PROJECT
TENDER NO.
SUBJECT

: STEAM GENERATION PLANT AT TALCHER, ODISHA
: PNMM/PC-150/E-4003/NCB
: REPLY TO PRE-BID QUERIES : LOT 12 Dated 30.03.2021

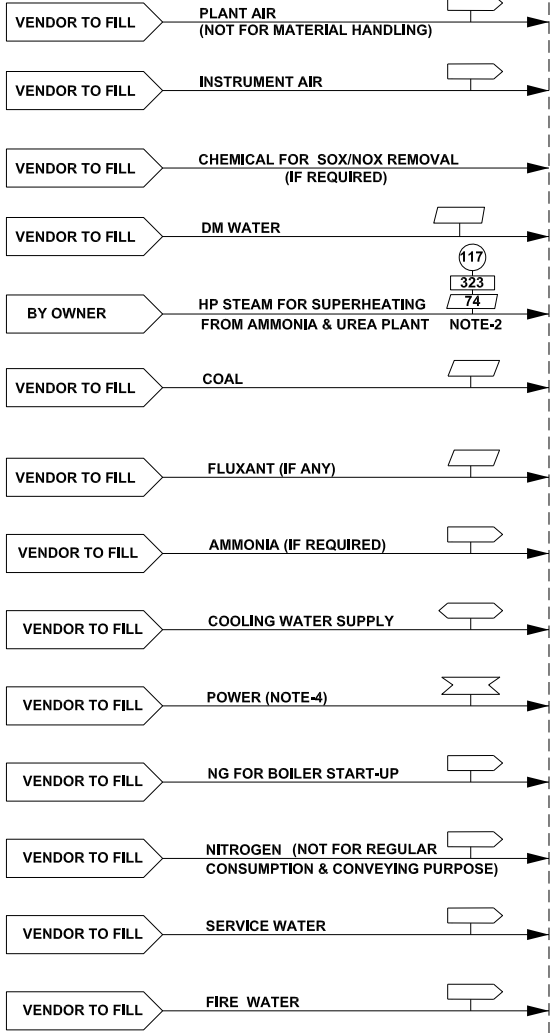
15.	Sheet 9 of 200 and Amendment-XV dated 08.02.2021 page no 33 of 122 S.no.67			Provision for 2x 45 MW STG and boiler in Plot plan	Please note that the future boiler and STG area covers the complete EDS area. Kindly check and confirm.	SGP Area as well as 2 x 45 MW STG and Boiler shall be accommodated in Area earmarked as 'Steam Generation Plant' in Plot Plan. Electrical Distribution System is dedicated for other facilities and cannot be provided for SGP Package. Bidder to design Layout accordingly.

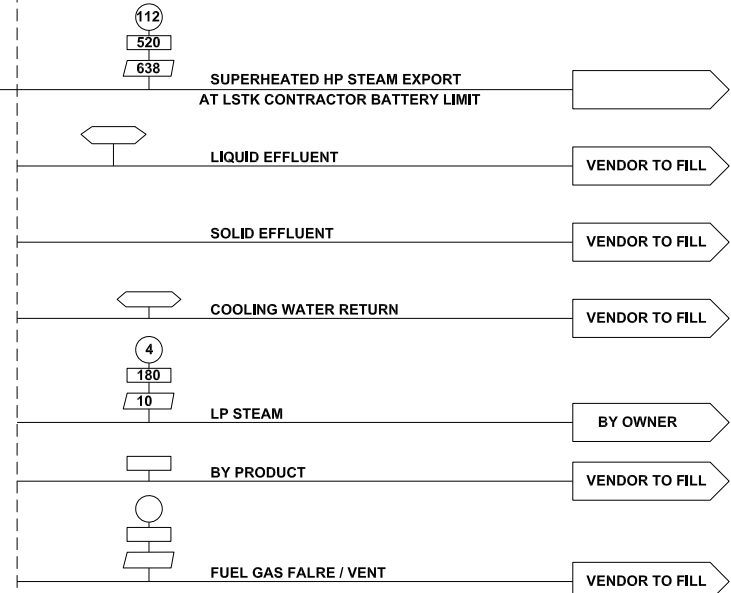
11.	Amendment No. XVIII dated 09.03.21	Page 1 of 7/ Sl.No.1		Revised Attachment-2 dated 04.03.2021 is attached	There is no attachment -2 dated 04.03.2021 available wuith the Amendment. Request provide the same.	Refereed attachment-2 dated 04.03.2021 is attached.
